Addendum No. M-02

Reference: Added Scope and clarification

Issue Date: November 6, 2024

Project: UHN TWH – SEM & Corridor (EXP Project Number MRK-23004289-A0)

TITLE:
 LEVEL 1 FLOOR PLAN - CORRIDOR - NEW
 WORK - PIPING

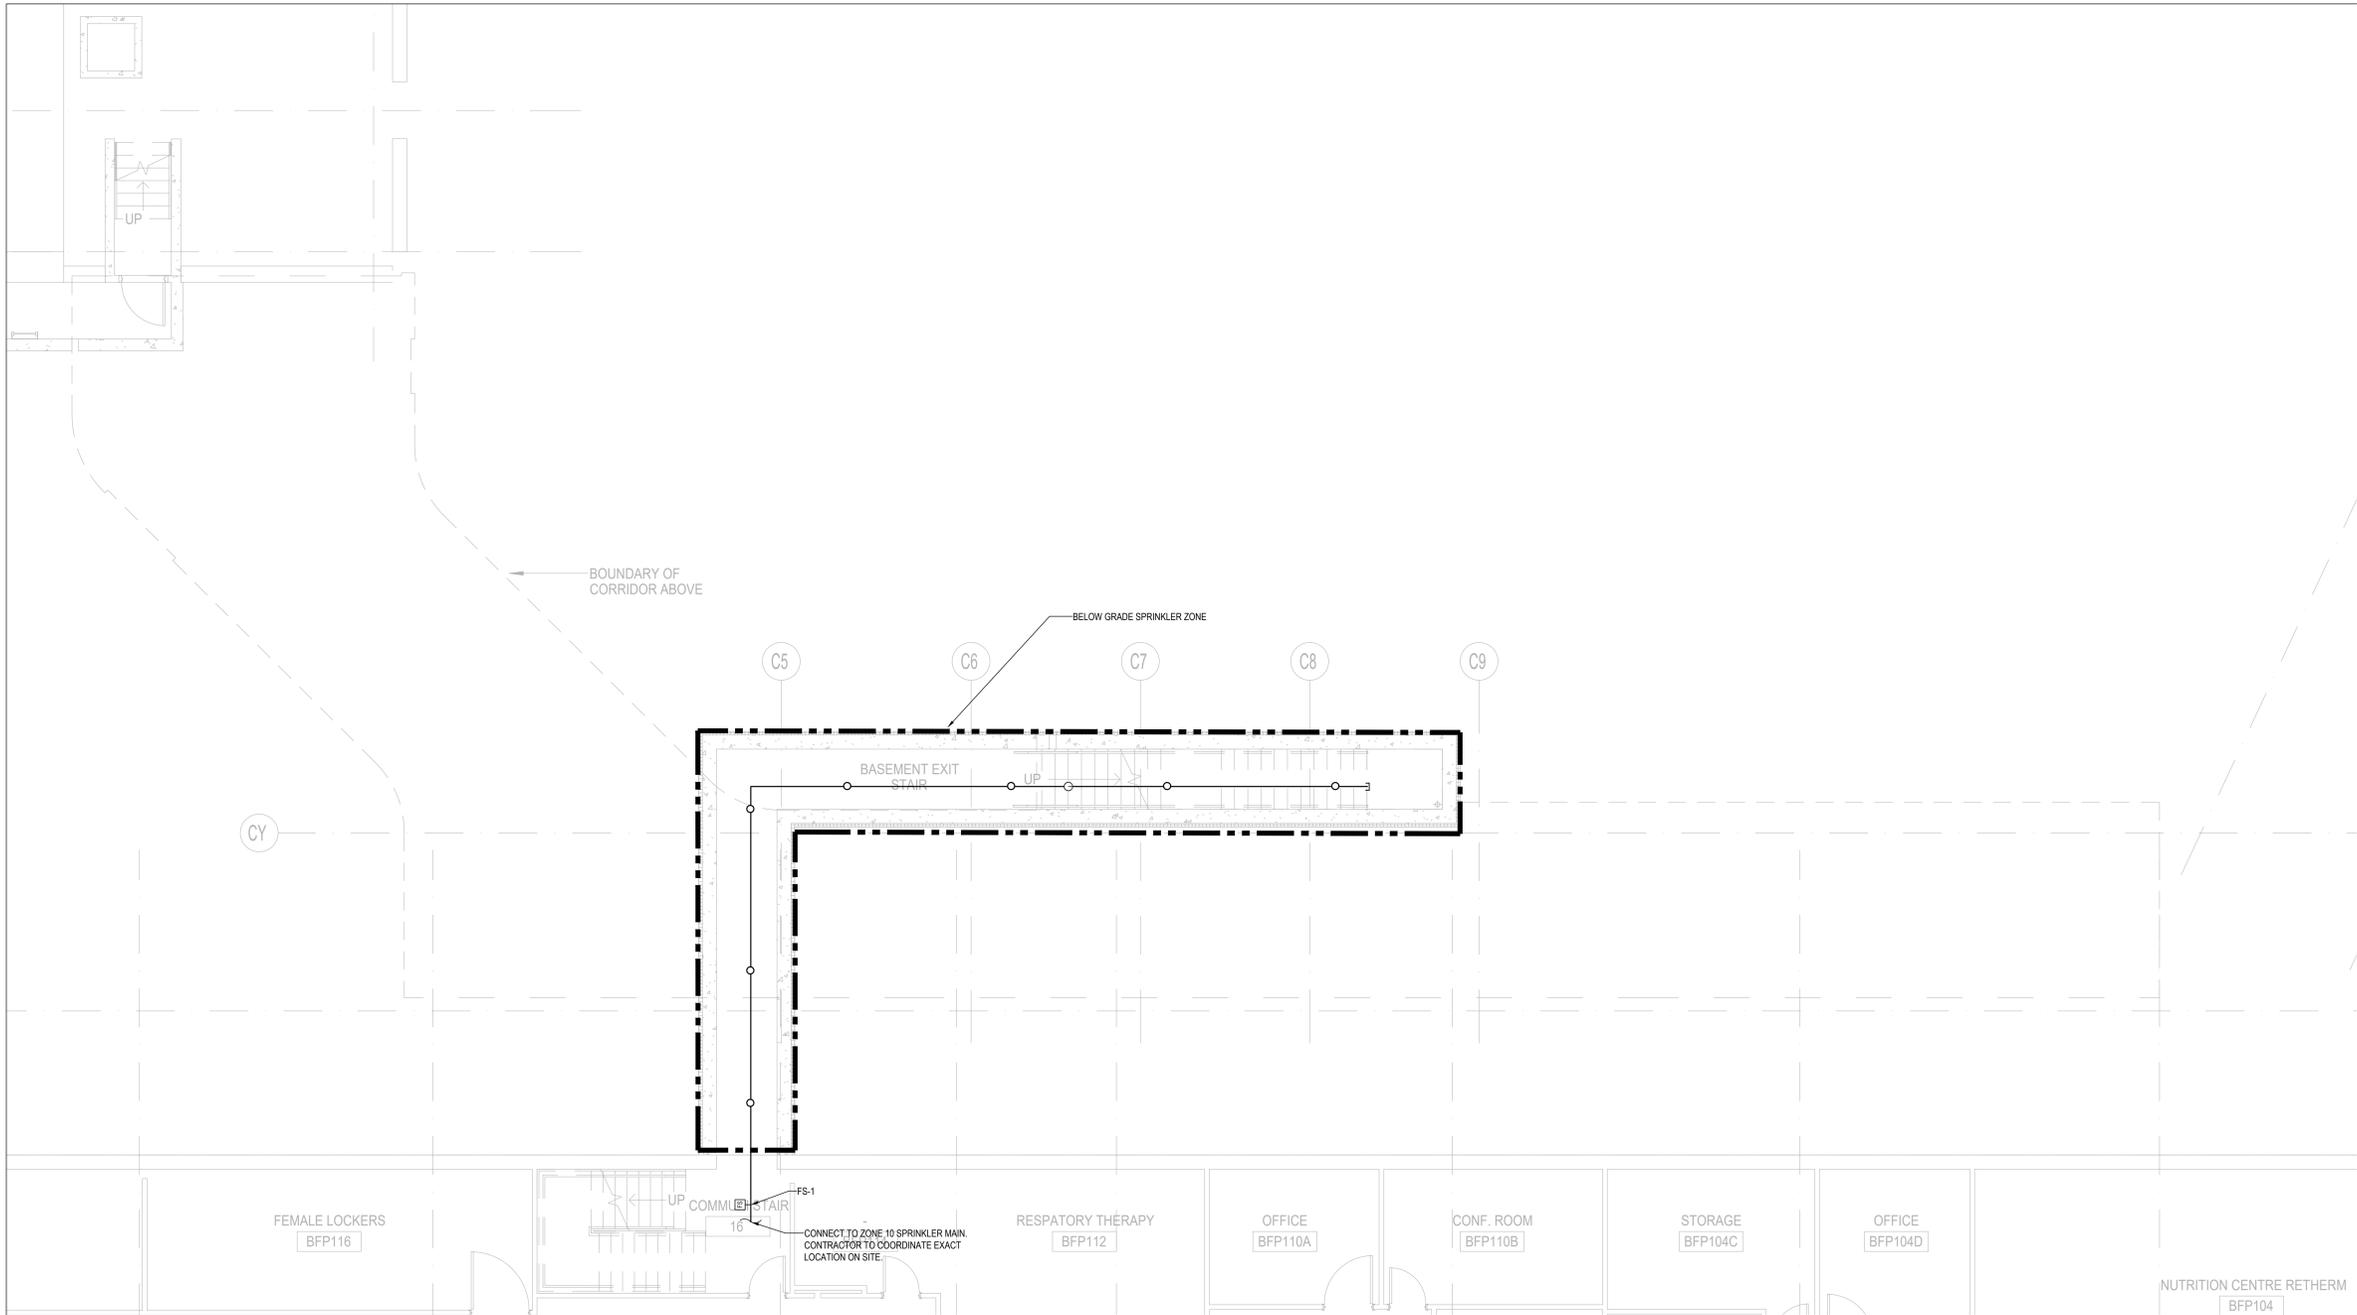
1.1.13. M-311B – LEVEL 1 FLOOR PLAN – CORRIDOR – NEW WORK – PIPING

- .1 Updated equipment size.

LEVEL 1 FLOOR PLAN - CORRIDOR - NEW WORK - FIRE PROTECTION

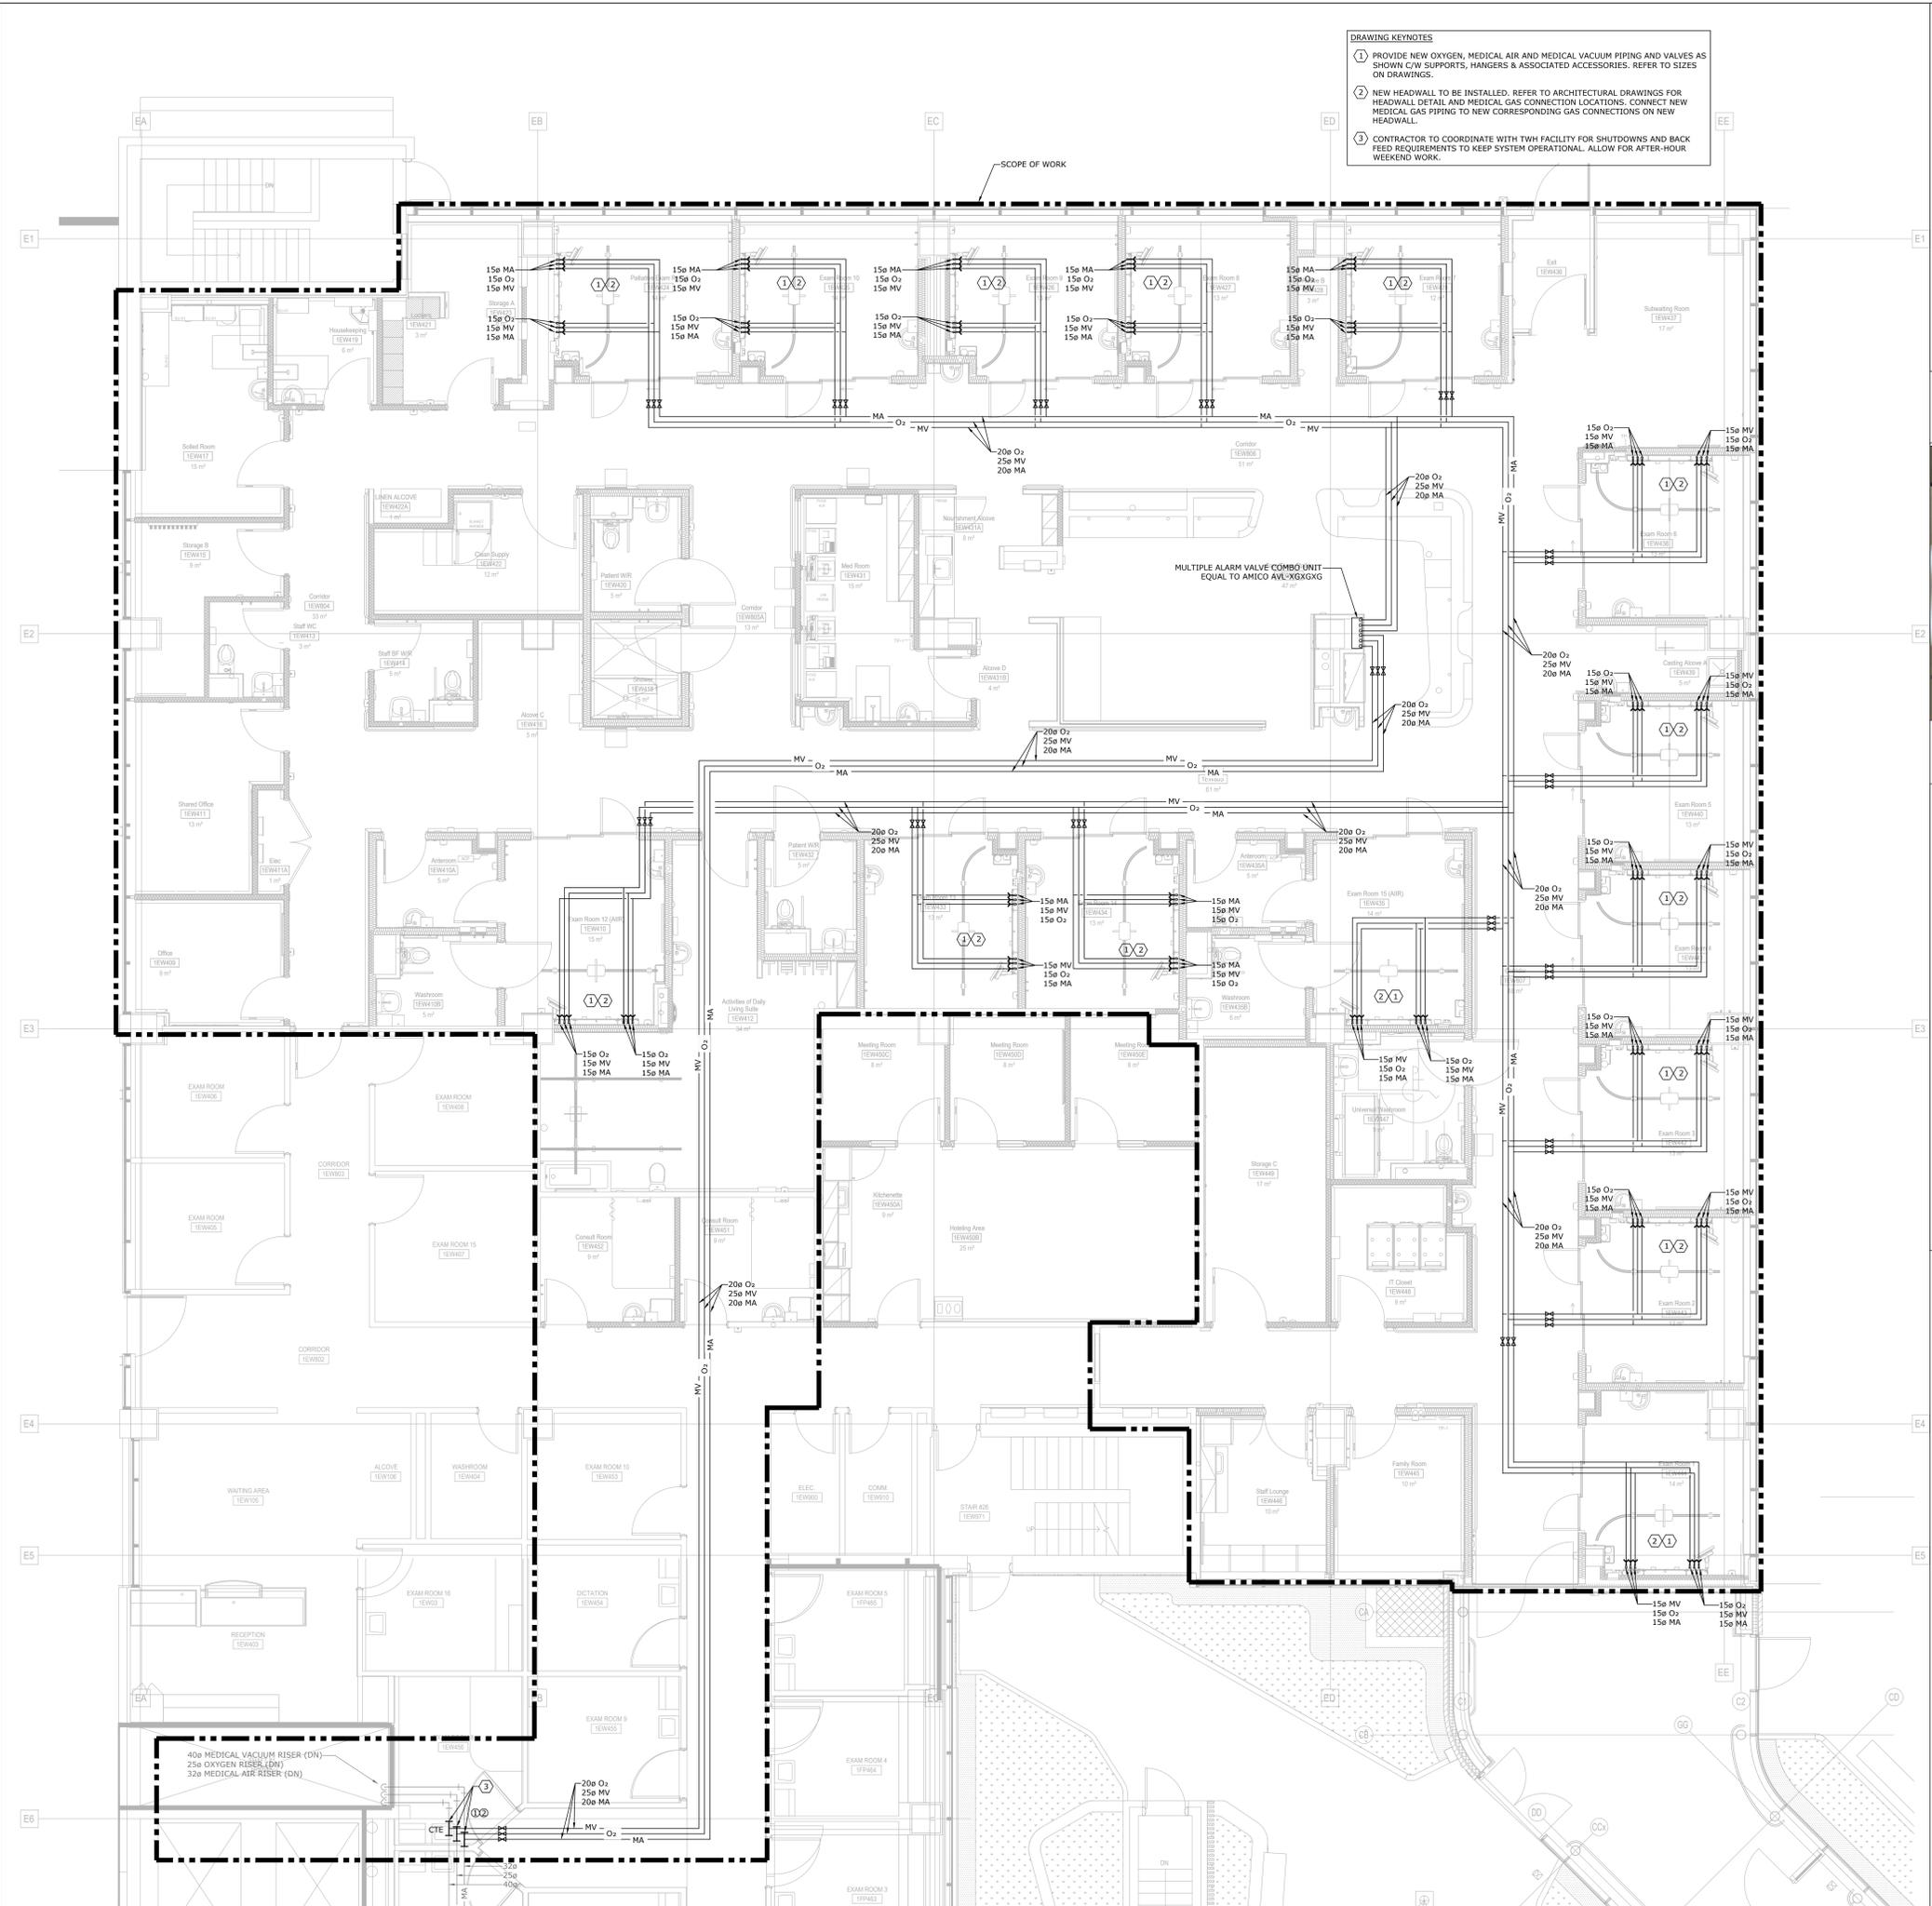
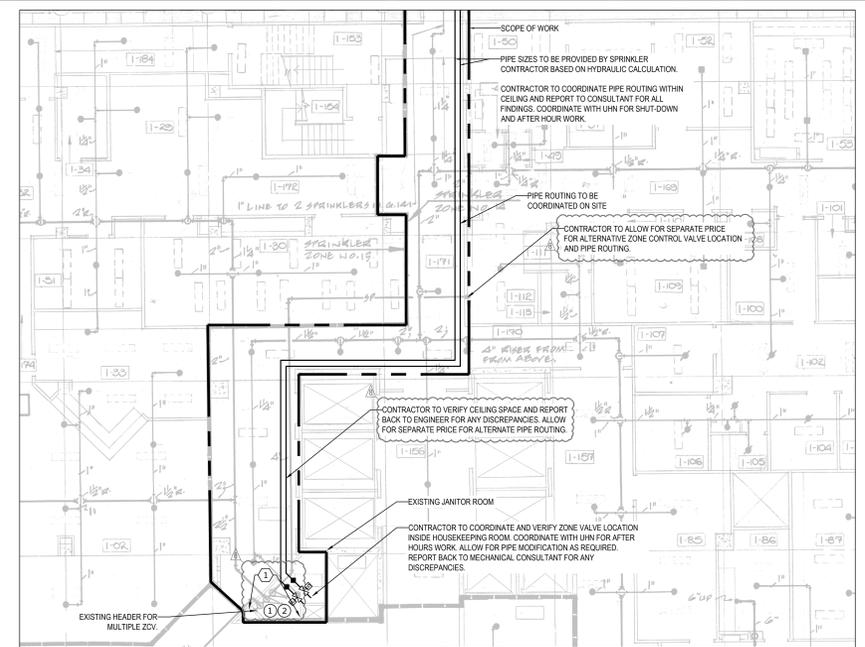
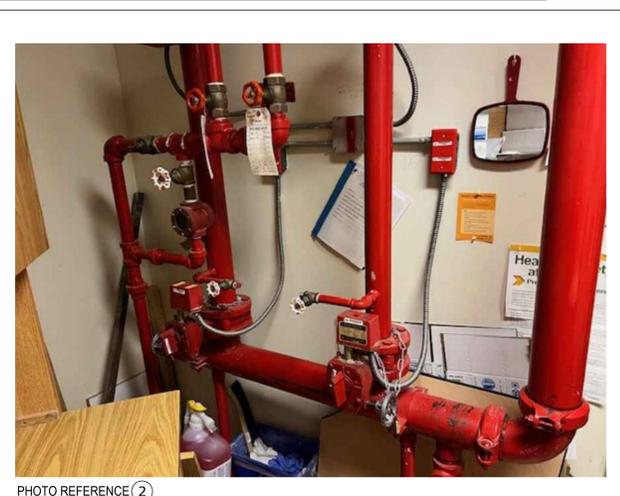
1.1.15. M-411B – LEVEL 1 FLOOR PLAN – CORRIDOR – NEW WORK

- .1 Added fire extinguishers to serve the corridor.
- .2 Removed the floor drain in the janitor room.
- .3 Added note for flushing and scoping of existing hub drain and housekeeping drain.
- .4 Added notes for janitor room sprinkler pipe connections.
